## Application for Works Approval

| <b>Works Approval Number</b> | W6689/2022/1  |
| <b>Applicant</b>             | Kalgoorlie Consolidated Gold Mines Pty Ltd  |
| <b>Premises</b>              | Fimiston Processing Plant<br>Tenements M26/383, M26/294, M26/359<br>KALGOORLIE WA 6430<br>As defined by the premises map attached to the issued works approval. |

**Figure 4: Noise contour plots for Scenario 2 and Scenario 3**

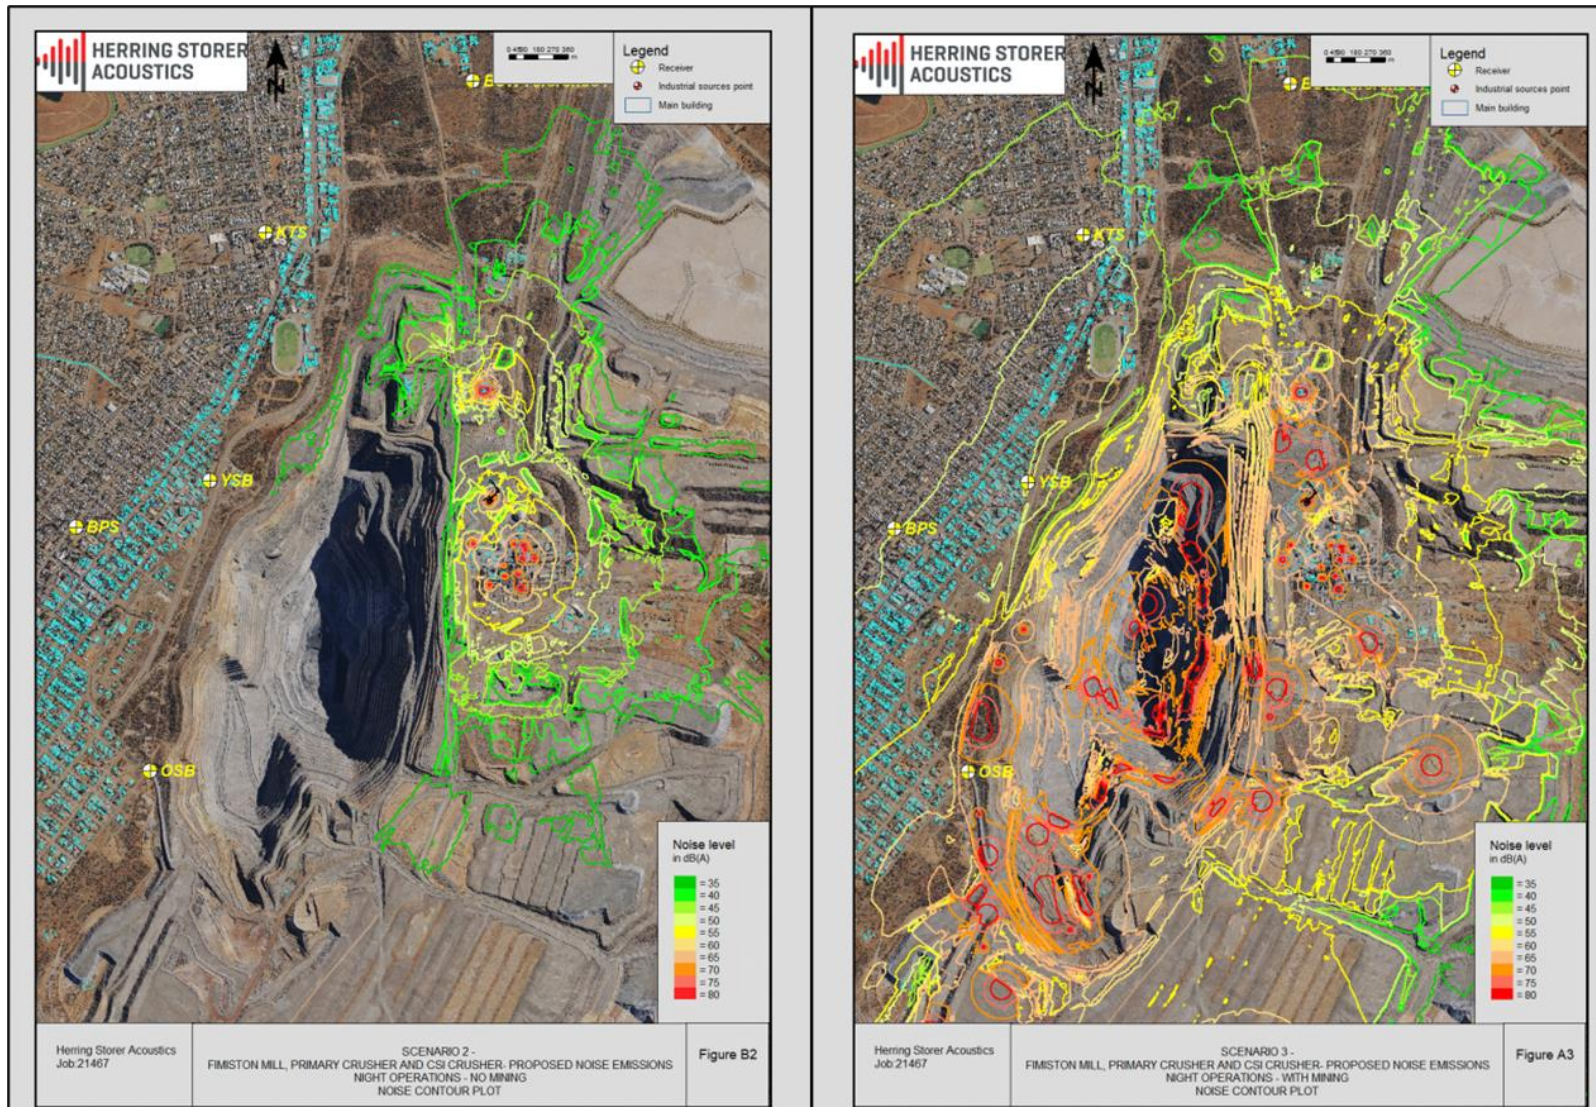
To assess the potential noise impacts from the revitalised processing plant, the applicant undertook an environmental noise assessment (Herring Storer Acoustics 2022). The assessment predicted noise levels at five compliance noise monitoring locations, including the Boulder Primary School (BPS) (Figure 4). Noise levels were calculated under three scenarios, including current mill and crushing only (Scenario 1), current and proposed increased mill and crushing (Scenario 2) and current and proposed mill, crushing and mining operations (Scenario 3) (Table 4). Predicted noise contour plots are shown in Figure 4.

Considering only the proposed revitalisation of the processing plant, a general increase of 3 dB(A) was predicted at all the noise monitoring locations within the township. The overall noise levels from the processing plant were significantly below the assigned noise levels at these locations (Table 4). Scenario 3 indicated noise from the processing plant were at least 10 dB lower than the mining noise levels, the proposed progressing activities would not significantly impact the overall noise levels at the monitoring locations.

In considering the outcomes of the noise assessment, the consequence of this risk event is **minor**, considering that noise emissions from the revitalised process plant is unlikely to be a significant contributor to the overall noise emissions from the wider KCGM operation.

The likelihood of this risk event is **unlikely** and may be dependent on specific timing and meteorological conditions.

The resultant risk rating is **medium**. The applicant's proposed controls are conditioned within the works approval, in accordance with *Guideline: Risk Assessments* (DWER 2020b). Given the controls already in place, the Delegated Officer has decided that no additional operational controls are required to manage noise emissions during time limited operations. Compliance to the *Environmental Protection (Fimiston Gold Mine Noise Emissions) Approval 2016* must still be demonstrated.

**Figure 5: Mean pollutant mass emission rate and removal efficiency (%) of components of KOGCC for (a) mercury, (b) total VOC and (c) PM<sub>10</sub>**

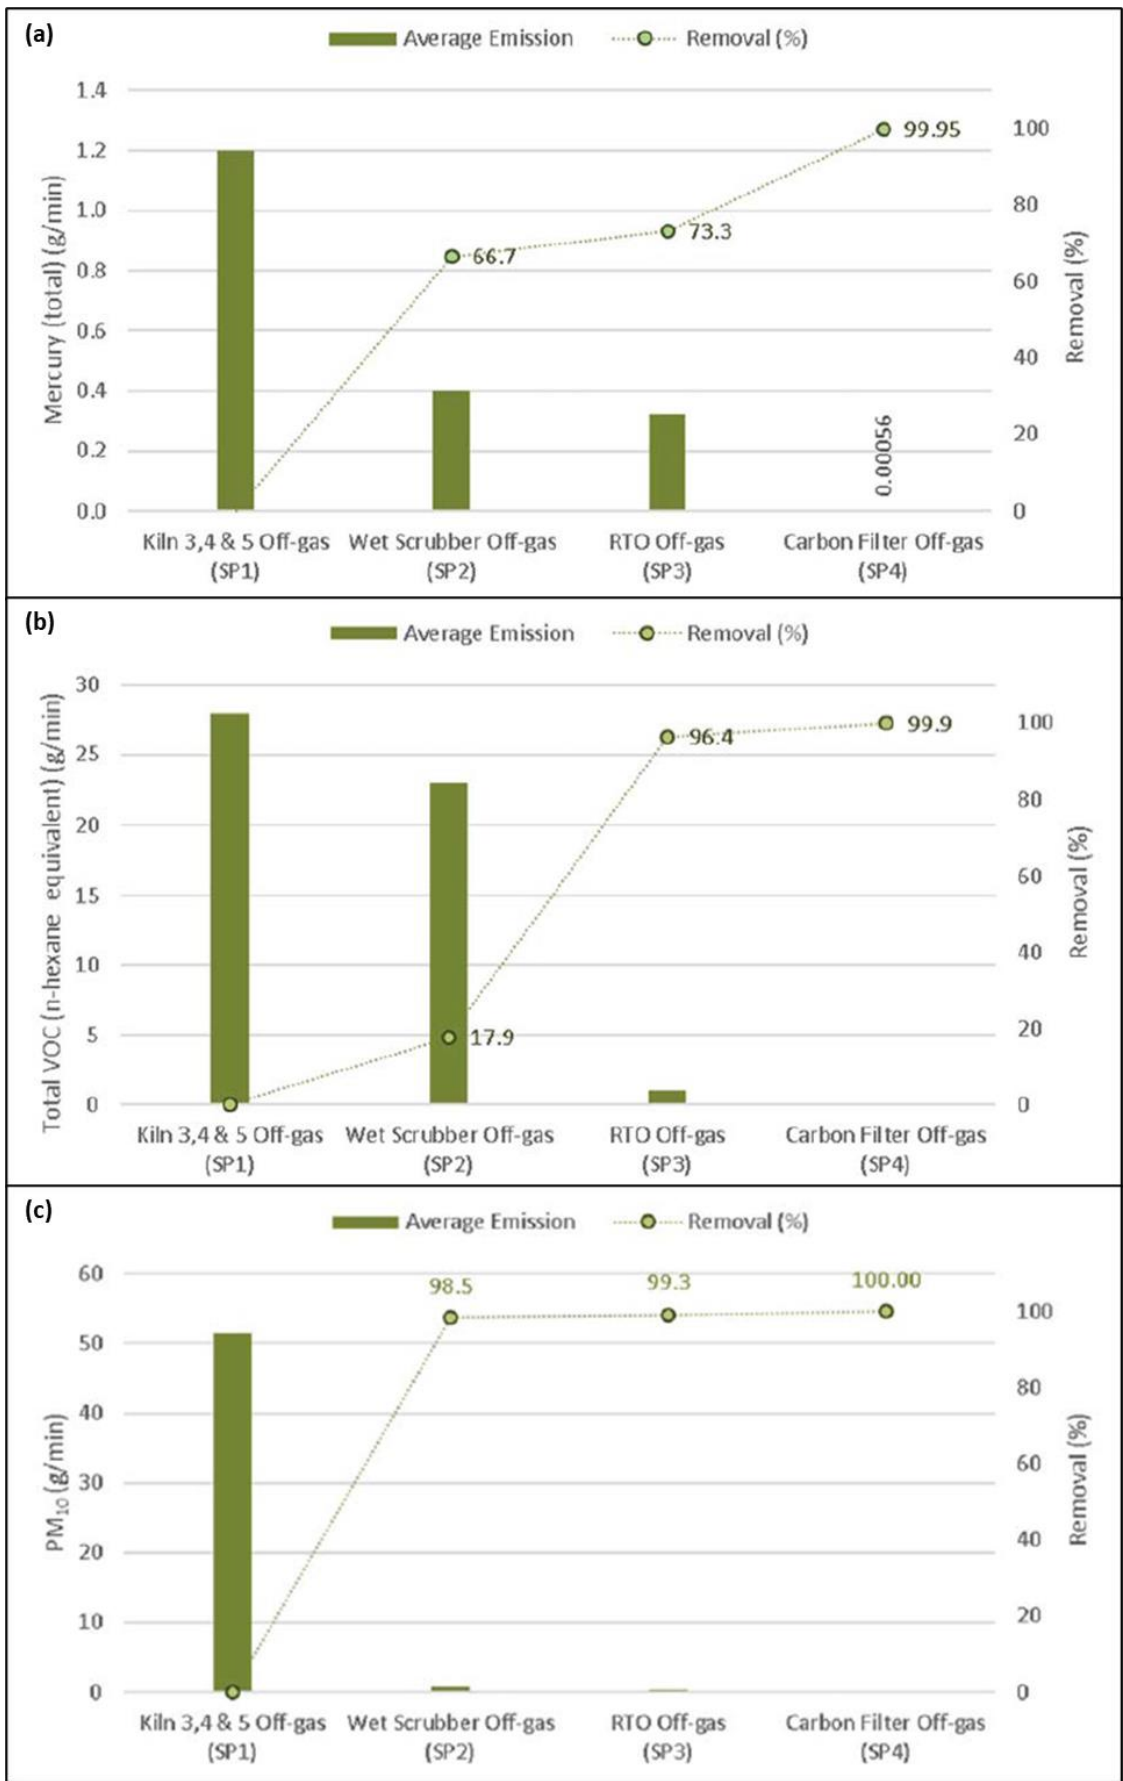
As part of the Fimiston Processing Plant Revitalisation, the applicant intends to install a duplicate KOGCC for the new carbon regeneration kiln without an RTO unit. Post-commissioning monitoring of the existing KOGCC indicated that the RTO resulted in only a

1.18% and 6.67% reduction in off-gas mercury concentration and emission rates, respectively, which was less effective compared to the wet scrubber and carbon filter (Figure 5a) (KCGM 2020). Further, the applicant experienced issues with the performance of the RTO during commissioning (KCGM 2019). Hence, the RTO was omitted from the duplicate KOGCC design.

Nevertheless, it was also observed that the RTO was the largest contributor for reducing total VOC concentration and emission rates (i.e., 69.5% and 78.6%, respectively) (Figure 5b). Therefore, the omission of the RTO may result in higher VOC emissions from the duplicate kiln stack.

**Figure 6: Annual average predicted ground level concentration ( $\mu\text{g}/\text{m}^3$ ) of (a) mercury and (b) benzene under Scenario 2 with 20 m stack height**

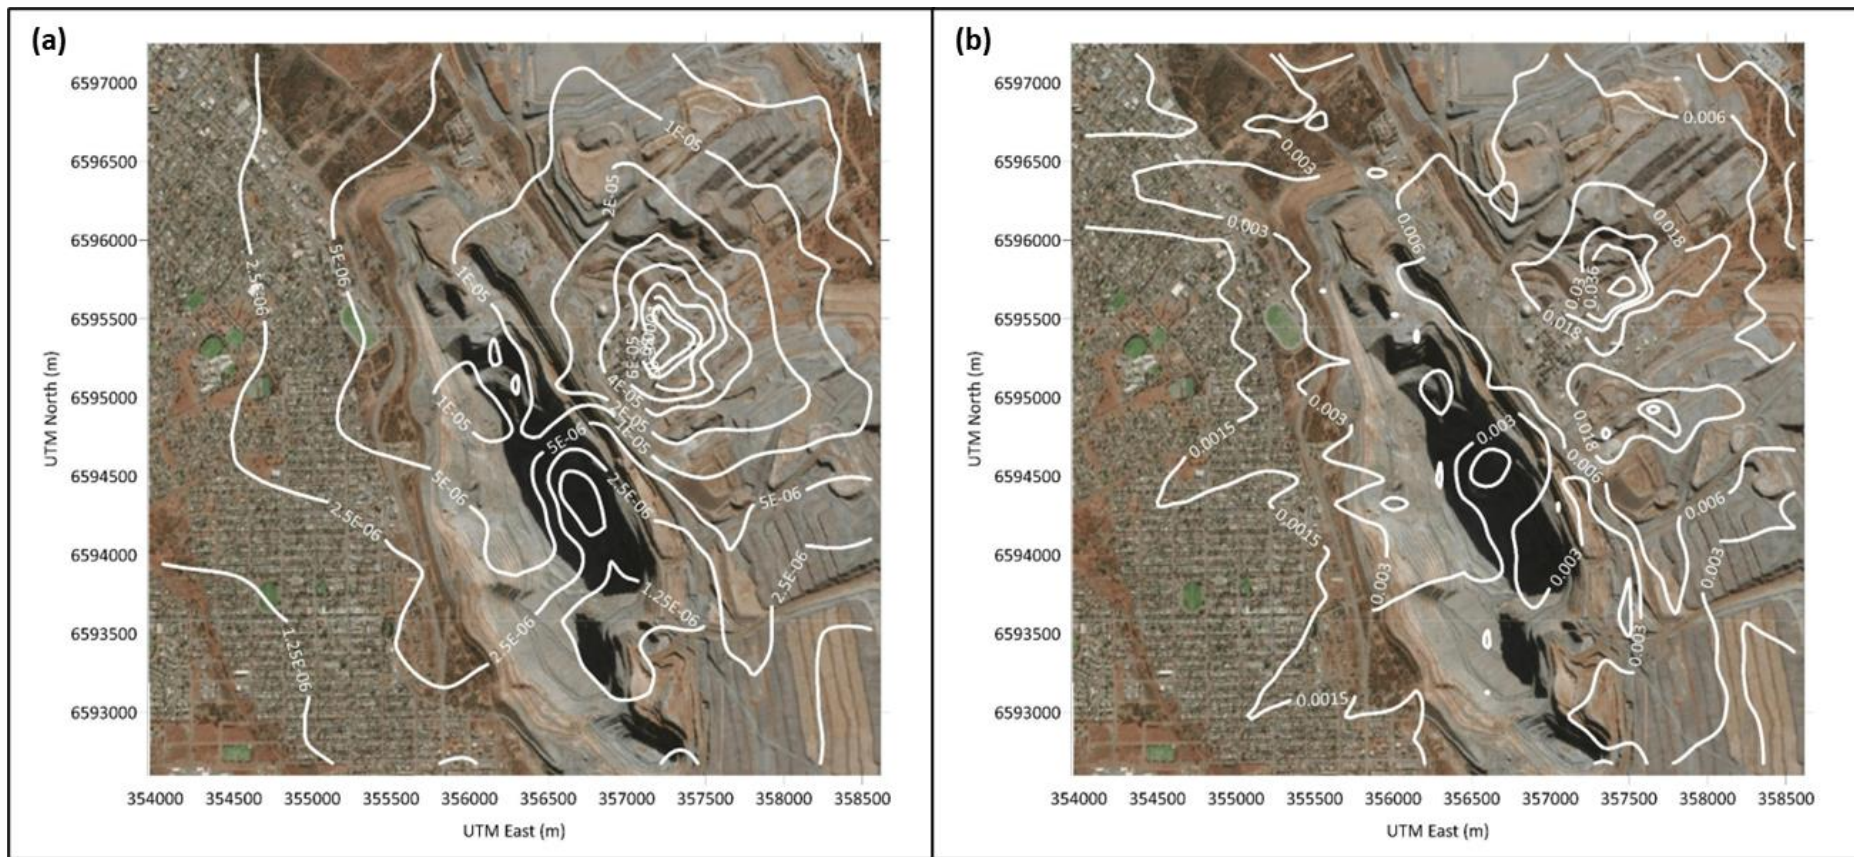
Based on the model, ground level concentrations (GLCs) for all contaminants of potential concern were below the ambient air quality criteria at all locations (onsite and offsite) within the modelled domain for all scenarios (Table 5). The highest predicted GLCs occurred at the premises, within the vicinity of the emission stacks (Figure 6).

Due to the exclusion of an RTO in Scenario 2 and 3, predicted benzene GLCs were higher, which agreed with findings from previous empirical data (KOGC 2020). Benzene GLCs decreased with increasing stack height used in Scenario 2. Nevertheless, none of the benzene GLCs exceeded the relevant guideline value, with offsite benzene GLCs only reaching approximately 6% of the short-term guideline value. As such, the increase was not considered to have a significant impact on human health.

**Figure 7: Retort oven off-gas mercury vapour monitoring results for (a) Run 1, (b) Run 2 and (c) Run 3.**

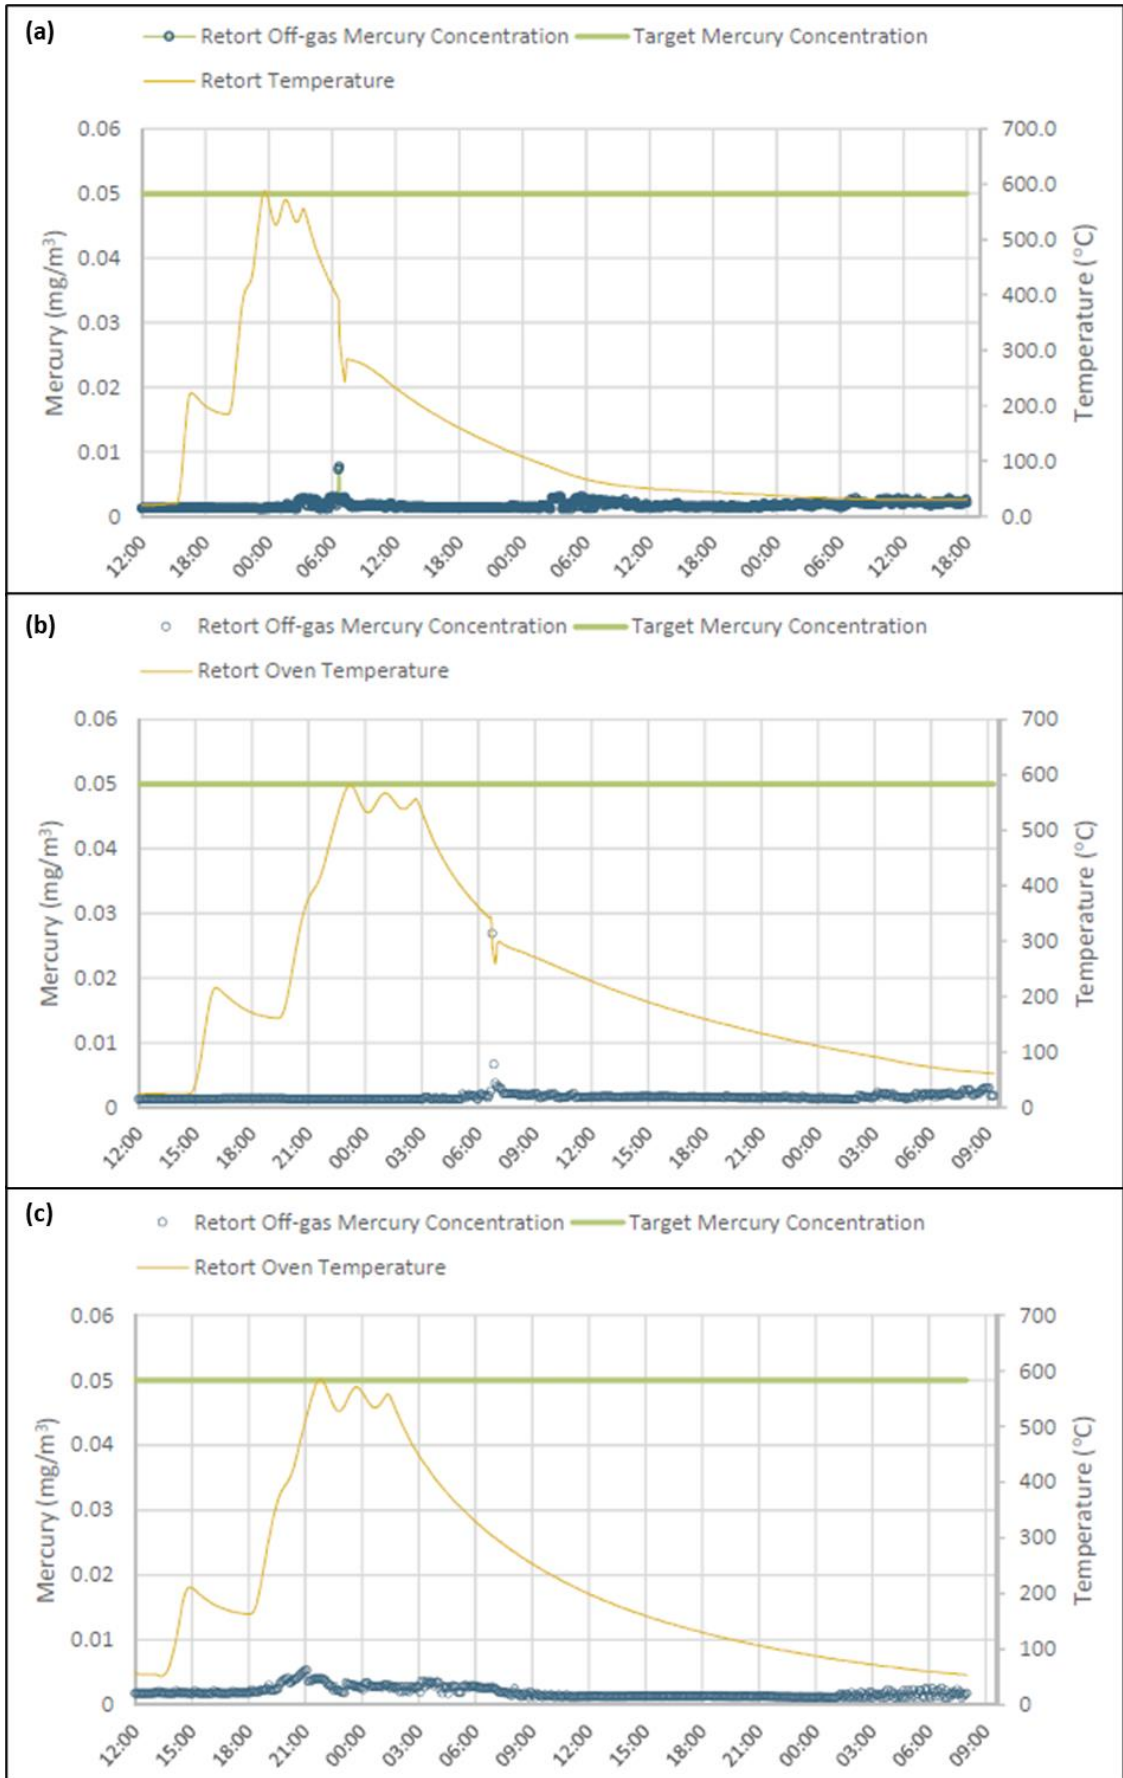
As part of the ERP, the installation of the retort oven, wet scrubber unit, mist eliminator and carbon filter were successful in removing elemental mercury from filter cakes (Table 6) and reducing off-gas mercury emissions released into the environment (Figure 7) (KCGM 2020).
